LIST OF SPECIAL INFORMATION EXPEDITOR

(This EO replaces EO 05-45B-5A dated 26 Aug 66)

TABLE OF CONTENTS

Figure 1

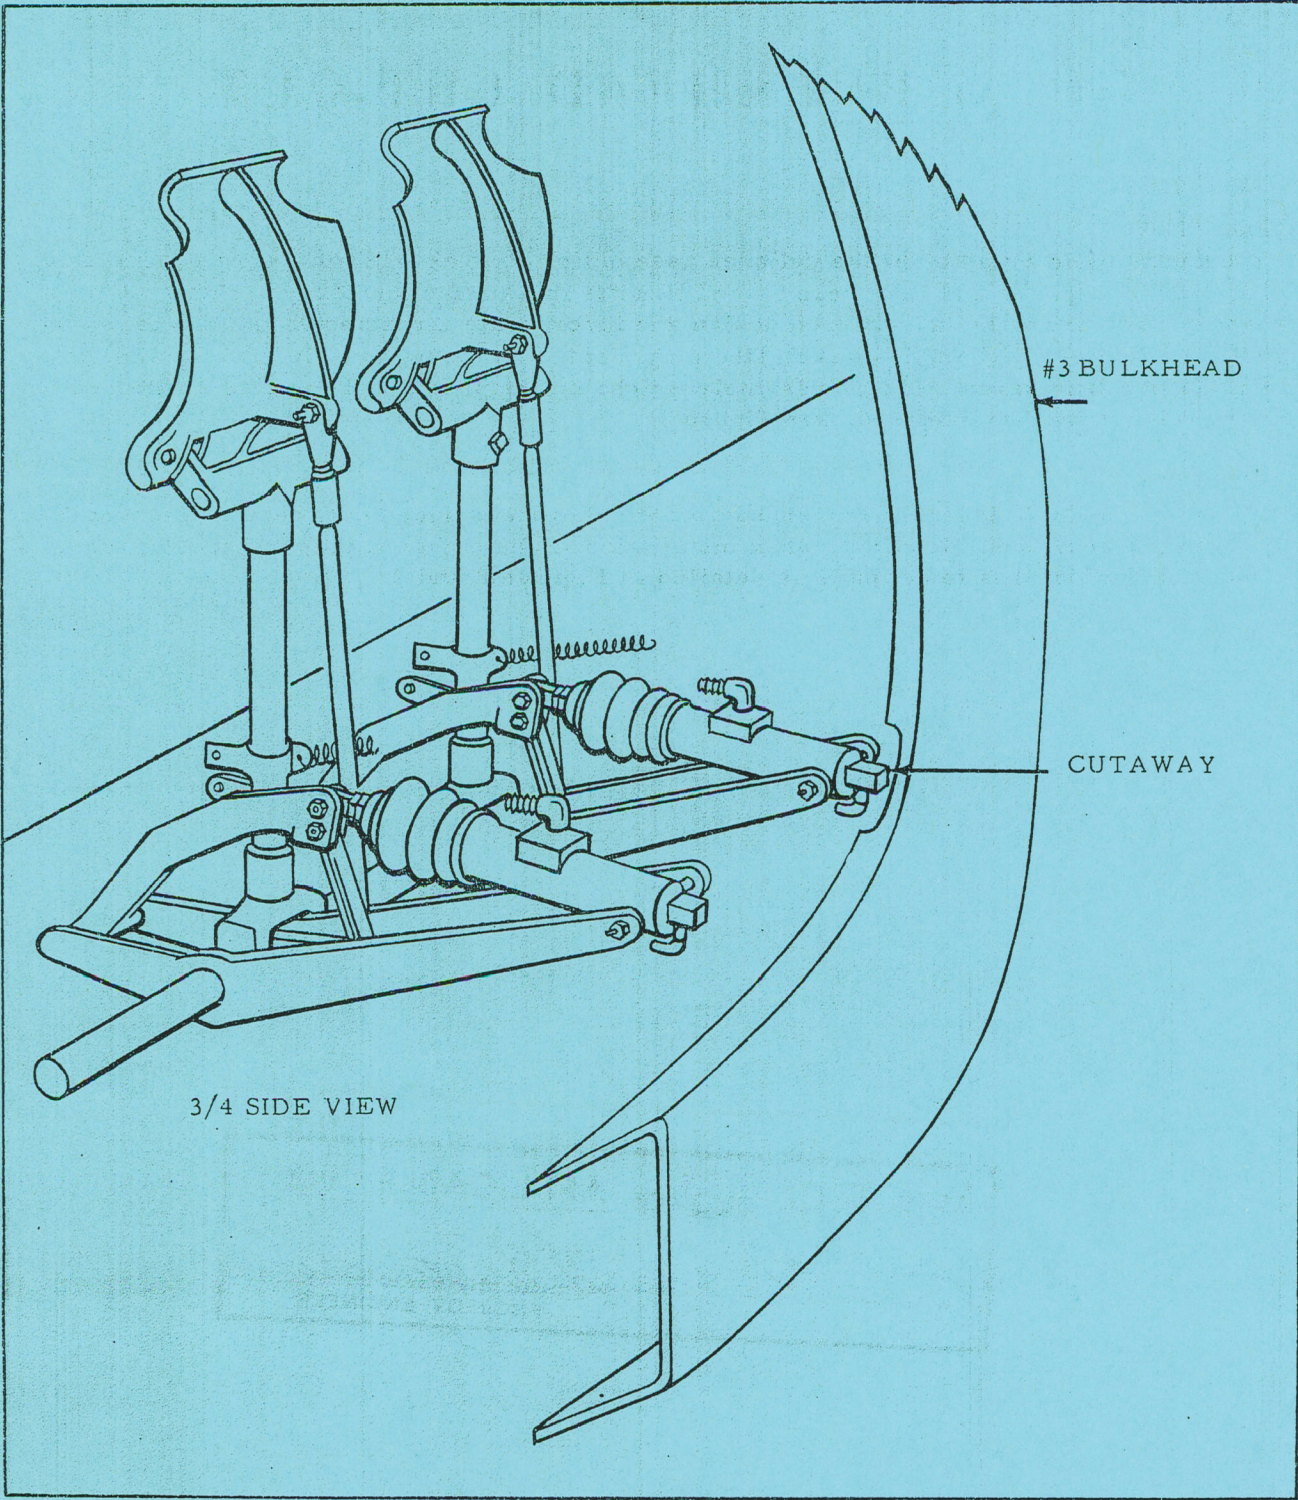
1 A quantity of new master brake cylinder assemblies Part 694-187800, were procured from Beech Aircraft as spares and have been issued to units in satisfaction of high priority demands. These assemblies are to the latest Beech design and incorporate a rectangular plug at the cylinder forward end whereas previous designs had the plug located on the under side. This design change has resulted in a lengthened cylinder assembly which, on the pilot's and co-pilot's outboard cylinders, interferes with #3 bulkhead, see Figure 1.

Figure 2

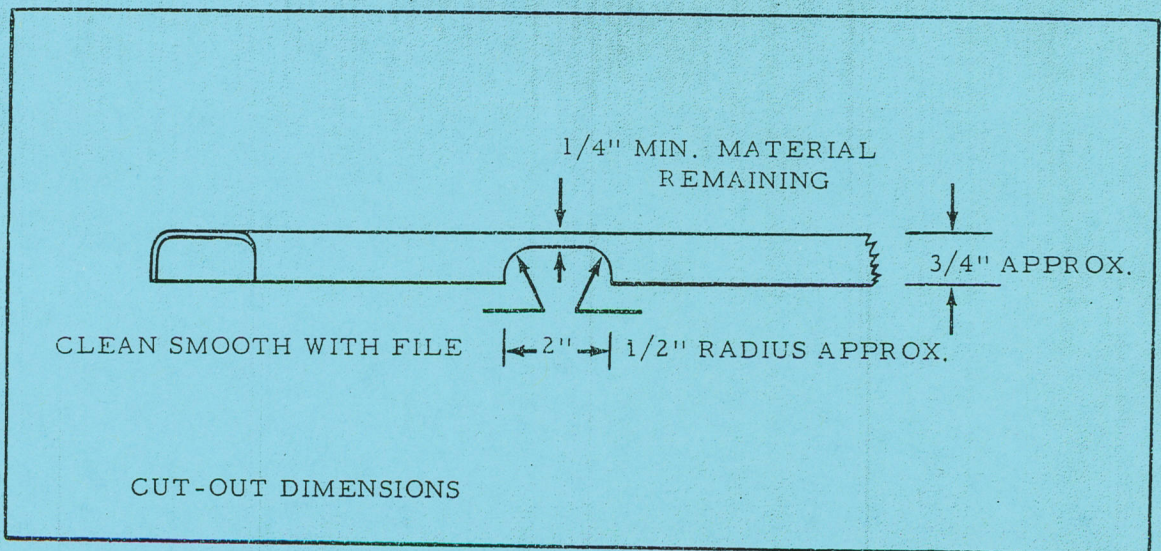
2 Wherever possible it is recommended that the above described cylinders be located in the inboard cylinder positions. However, when installation in the outboard position(s) is unavoidable a cut-out on #3 bulkhead is to be made as detailed in Figures 2 and 3

Figure 1

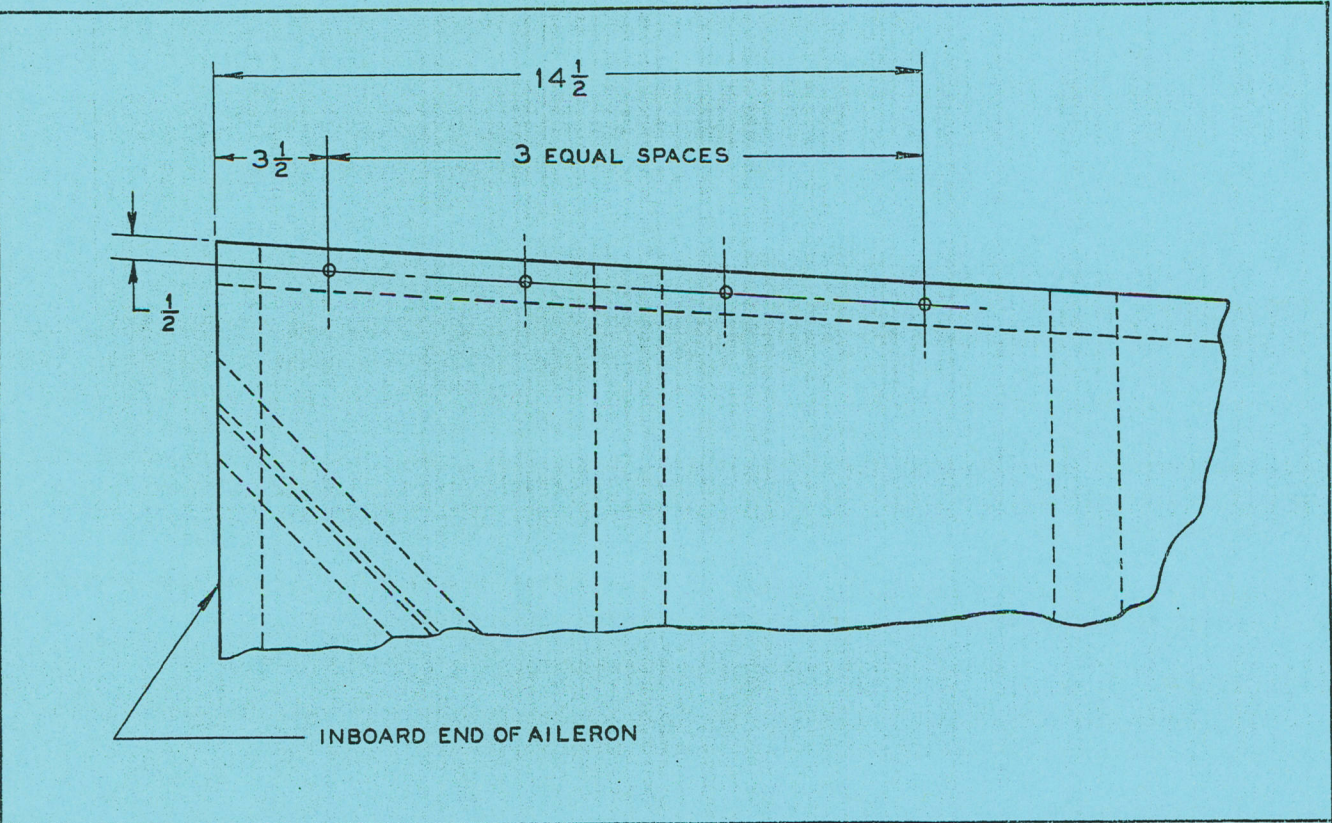
- (a) Lay-out position of riv-nut holes per Figure 1.
- (b) Cut holes in lower side of aileron fabric large enough to allow riv-nut heads to nest on trailing edge structure.
- (c) Drill trailing edge and install 6K75, RCAF Ref. 28/14958, riv-nuts.
- (d) Patch fabric on upper side.
- (e) Manufacture tabs per Figure 2 and install using AN526-632-6, RCAF Ref. 28/10010 screws.
- (f) The tab setting angles are to be determined by test flight of the aircraft under normal loading conditions and the adjustable tab in neutral.
